## STAFF REPORT 1/5/2022

**SUBJECT:** Fountainhead Plaza (Continued from December 15, 2021)

**SPECIFICS:** Tentative Parcel Map 37940 (Revision), Conditional Use Permit (CUP) 346, CUP 347, CUP 321 (modification), Architectural Review (AR) 21-12, and AR 20-03 (modification) to develop 5.06 acres of an 8.25 acre property to include a 2,028 sq. ft. Starbucks drive thru building, a 2,600 sq. ft. Panda Express drive thru restaurant and a 20,442 sq. ft. Aldi supermarket with Type 20 Alcohol Sales (Off-Sale Beer and Wine) at the northeast corner of Cesar Chavez Street and First Street (APN# 778-020-007 and 778-010-017). Applicant: Coachella Retail Realty Associates, LP.

**Figure 1 –TPM 37940 Revision Comparison**

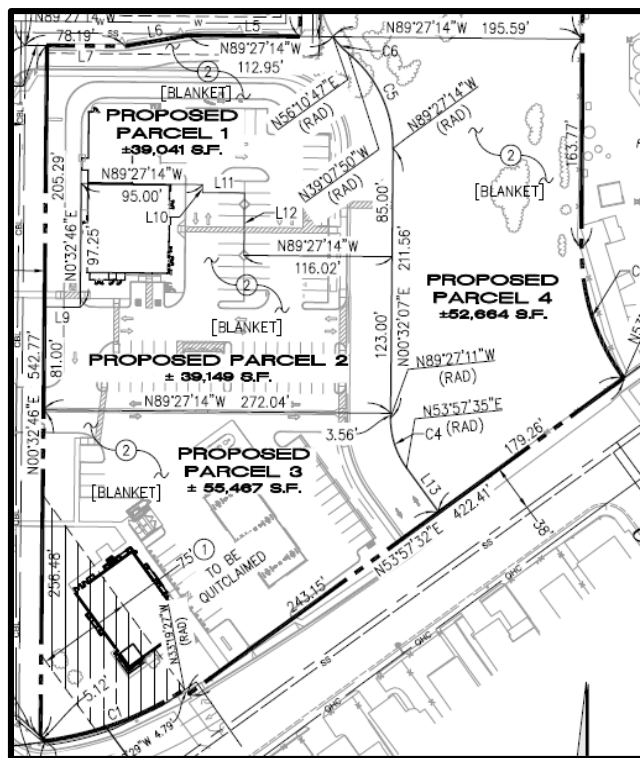
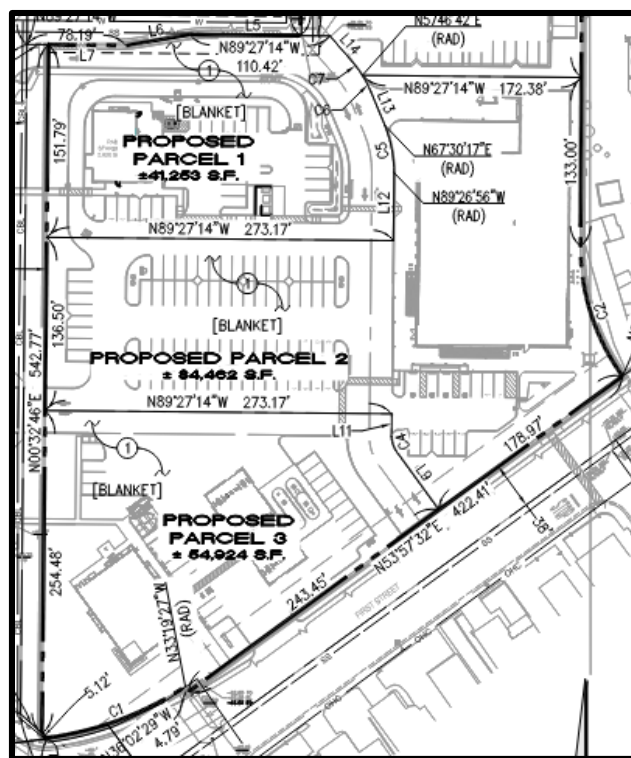
Tentative Parcel Map (TPM) No. 37940 was approved to subdivide the southern and eastern portions of the Walgreen's development (8.25 acres) into seven (7) parcels. The applicant proposes a revision to TPM No. 37940 where parcels 1, 2, and 3 would developed with the Starbucks drive-thru, Aldi supermarket, and convenience store with fuel service station respectively and Parcels 4, 5, 6 will be developed with a Panda Express drive thru restaurant (Parcel 4) and future commercial development. Parcel 7 contains the existing common-area retention basin that provides storm-water drainage needs of the developed properties (Walgreens, Taco Bell and McDonalds).

The information below is the proposed parcel (lot size) area breakdown and an exhibit of the proposed subdivision showing the new building areas and the “future” development areas.
